**YPSILANTI
TOWNSHIP**
— PLANNING & ZONING DEPARTMENT —

REGULAR MEETING AGENDA

Tuesday, July 28, 2026

- B. **PRELIMINARY SKETCH PLAN REVIEW – KALLITA TURBINES – 2830 TYLER RD –** TO CONSIDER THE CONSTRUCTION OF A 12,000 SQUARE FOOT STORAGE BUILDING ON A 9.8 ACRE SITE ZONED I-C, INDUSTRIAL AND COMMERCIAL

PROJECT NUMBER 33260	SHEET NUMBER
PROJECT DATE 3-4-2026	
CHECKED BY	C10.0

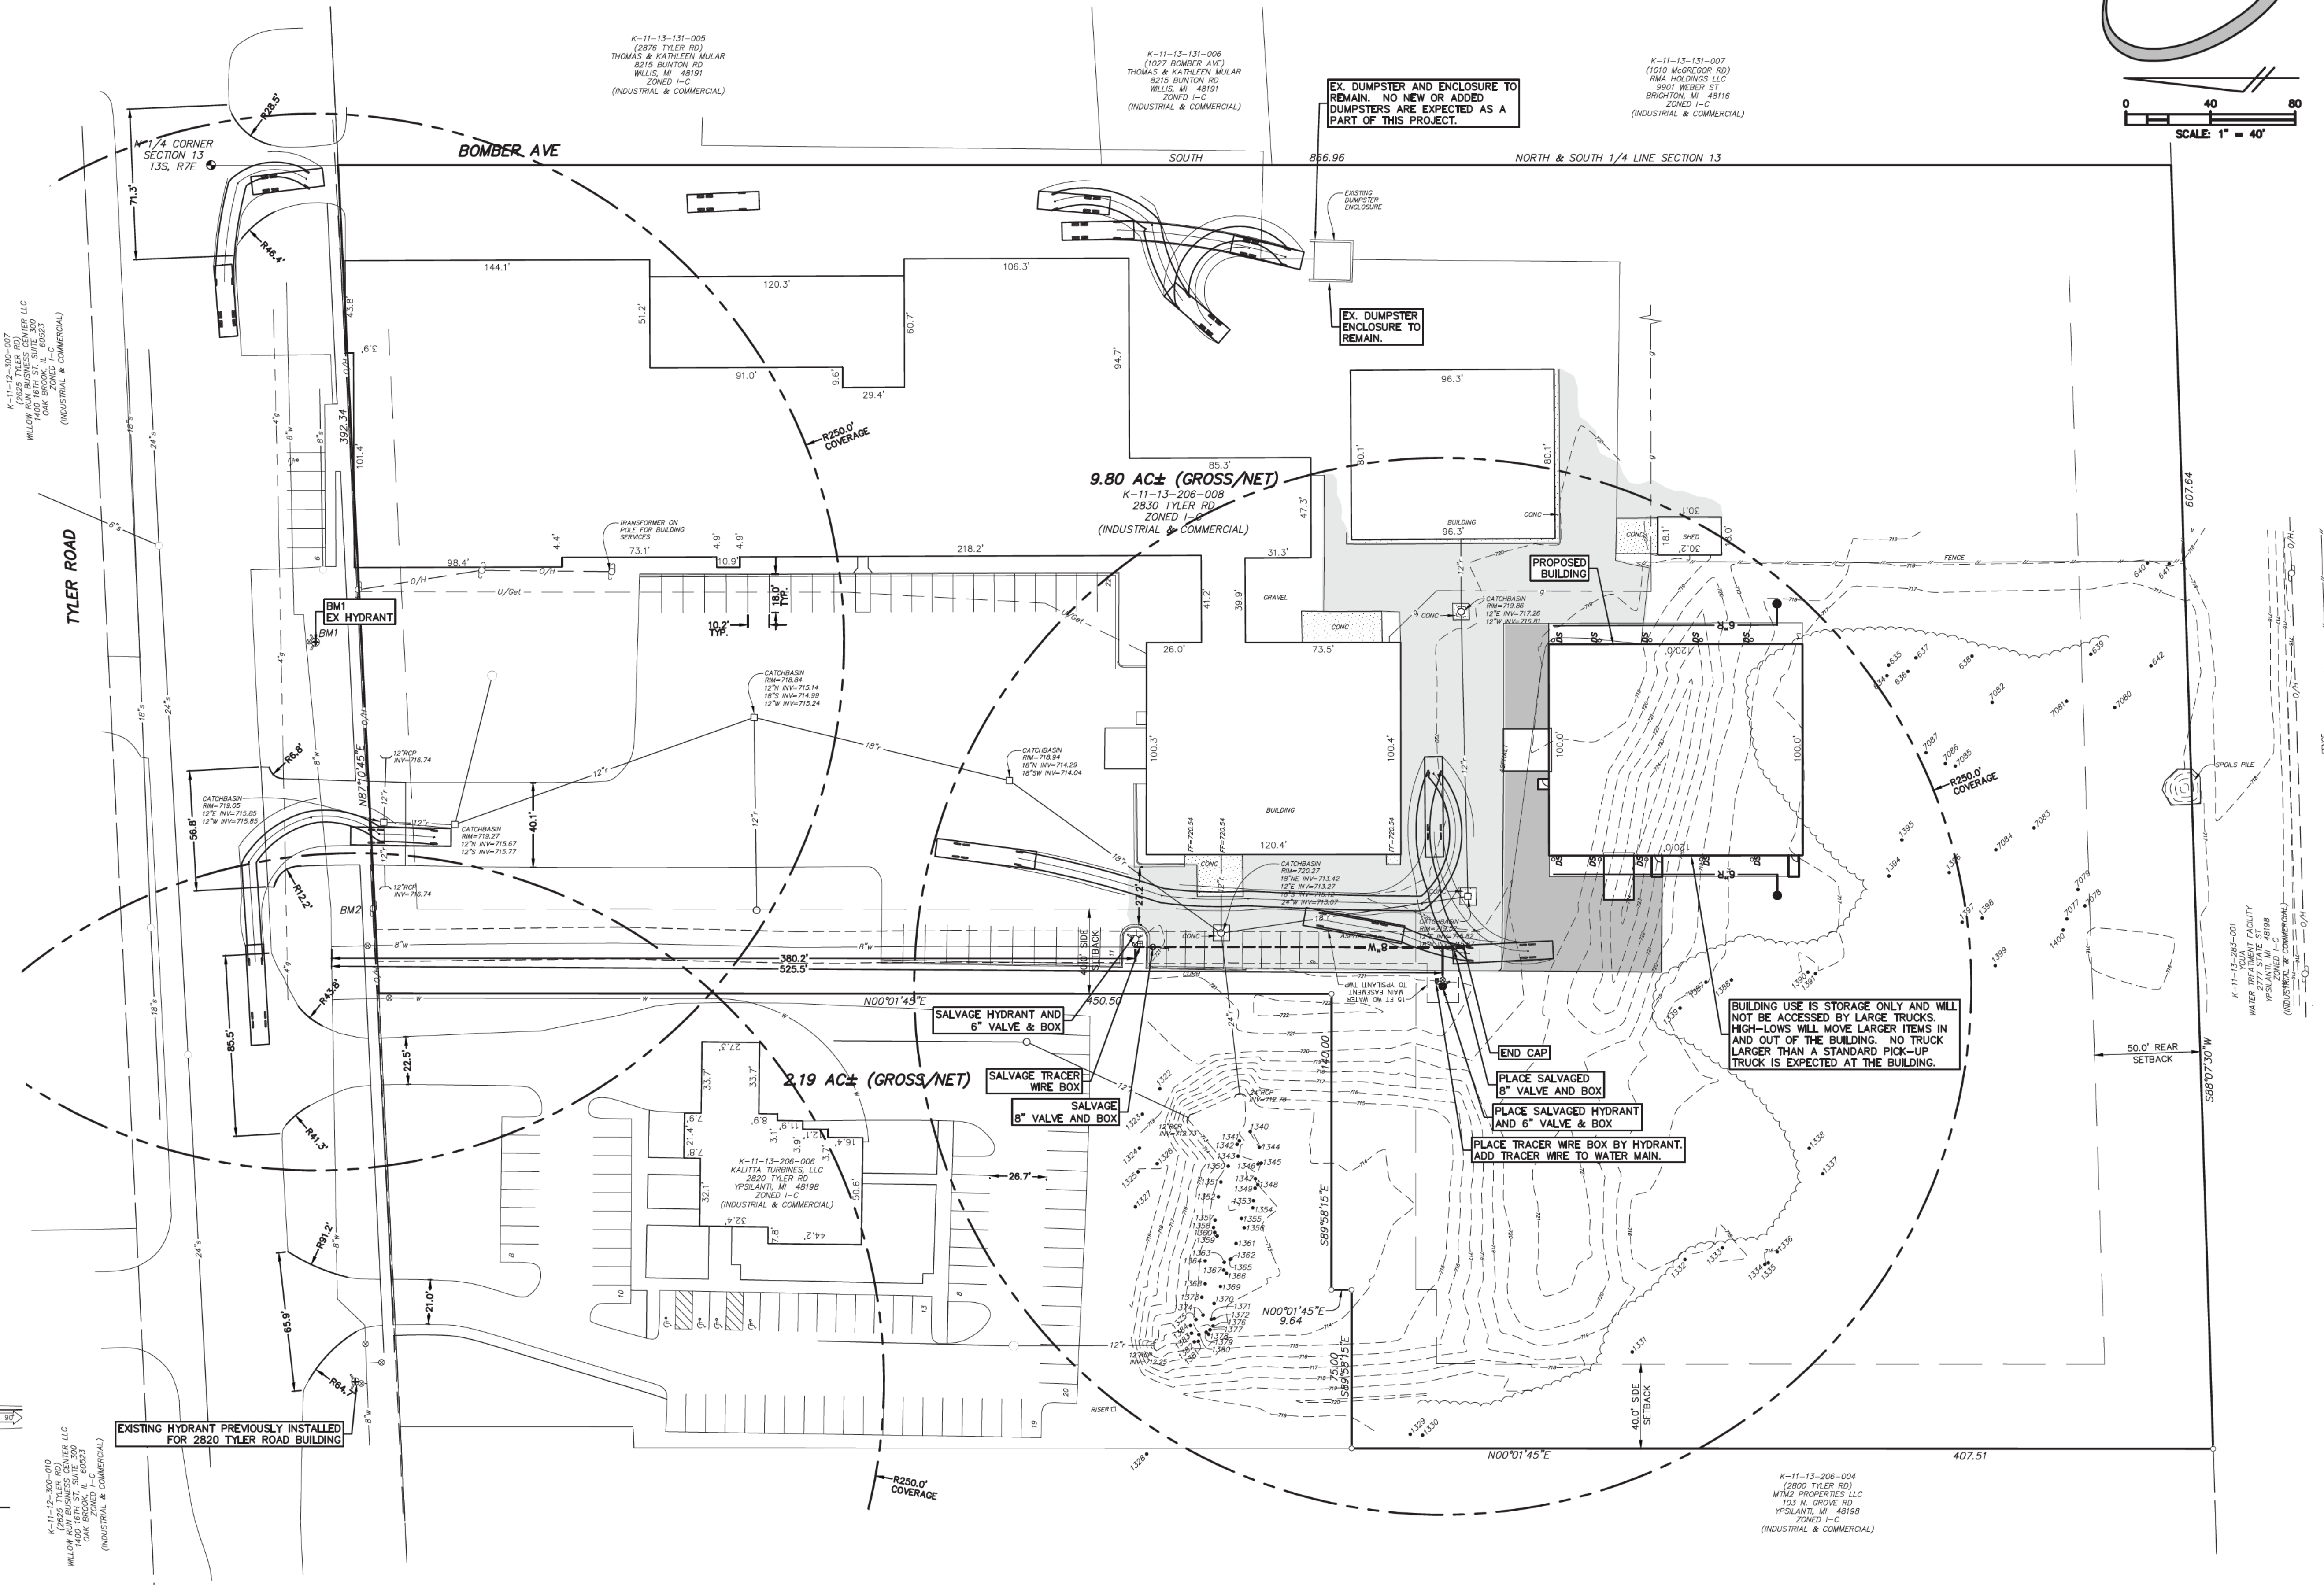
1. Provide truck turning movements in relation to new storage building to confirm access to overhead doors and adequate emergency vehicle access.
New sheet C10.0 has been added to plans to show truck movements for fire, solid waste, and access to new building.
2. Defer evaluation of circulation facilities to Township Fire Marshall.
Acknowledged.

2. The applicant shall provide a fire truck turning template to ensure sufficient space for accessibility has been provided.
Fire truck turning template has been added to the plans as sheet C10.0.

3. The applicant shall indicate how garbage will be collected and provide the location of the existing or proposed dumpster enclosure. If a dumpster enclosure is being proposed, the applicant shall provide a garbage truck turning template to ensure sufficient space for accessibility has been provided.
The existing dumpster is shown on the plans and turning template for access is shown on sheet C10.0.

The existing hydrant has been noted to be relocated to properly cover the building with 250' radius for building coverage and fire truck turning template has been added as sheet CD10.0.

Note: An additional sheet for Fire Protection/Solid Waste Plan has been added as sheet C10.0
